Contract #: 04-0120F4Cty: SF/ALA Rte: 80 PM: 13.2/13.9File #: 69.25B**QUALITY ASSURANCE -- NON-CONFORMANCE REPORT****Location:** Changxing Island, Shanghai, P.R. China**Report No:** NCR-000804**Prime Contractor:** American Bridge/Fluor Enterprises, a JV**Date:** 15-Jul-2010**Submitting Contractor:** Zhenhua Port Machinery Company, Ltd (ZPMC), Changxing Island**NCR #:** ZPMC-0766**Type of problem:**

Reference Description: QA found a 60mm long MT crack after the contractor's had tested and accepted a weld on a Traveler Rail

To: AMERICAN BRIDGE/FLUOR, A JV **Date:** 19-Jul-2010
 375 BURMA ROAD
 OAKLAND CA 95607 **Contract No:** 04-0120F4
 04-SF-80-13.2 / 13.9
Dear: Mr. Charles Kanapicki **Job Name:** SAS Superstructure
Attention: Mr. Thomas Nilsson Project/Fabrication Manager **Document No:** 05.03.06-000761
Subject: NCR No. ZPMC-0766

Subject: NCR No. ZPMC-0766

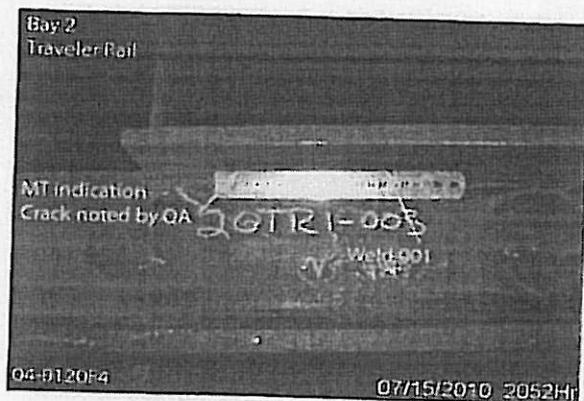
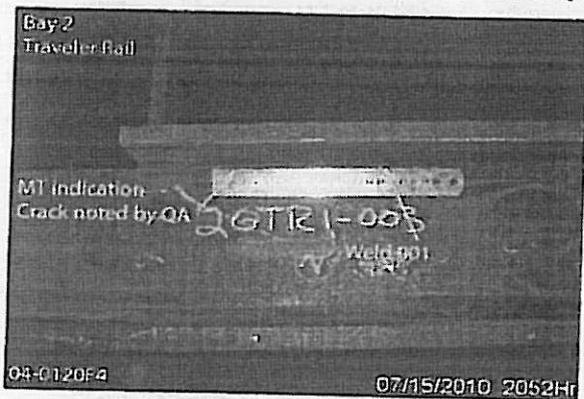
During Quality Assurance (QA) Magnetic Particle Testing (MT) review of welds located on Orthotropic Box Girder (OBG) Bottom Plate, this QA Inspector discovered the following issue:

- Weld identified as: 20TR1-003-001.
- One (1) longitudinal linear crack at the toe of the weld was found by QA.
- The "Y" location is approximately 60mm from the end of the stiffener.
- Length of Crack is 70mm.
- The weld is a CJP.
- This Traveler Rail is located in the OBG Sub assembly Bay #2.
- ZPMC QC agreed that this is a MT crack and will require a Critical Weld Repair (CWR)
- The Notice of Witness Inspection Number (NWIT) is 06206 item #4. The crack is located within the area that has been previously tested and accepted by ZPMC Quality Control (QC) personnel.

AWS D1.5 2002 Section 6 par.6.26.2 – Welds that are subject to RT or MT in addition to visual inspection shall have no cracks and shall be unacceptable if the RT or MT shows any of the types of discontinuities described in 6.26.2.1, 6.26.2.2, 6.26.2.3 or 6.26.2.4.
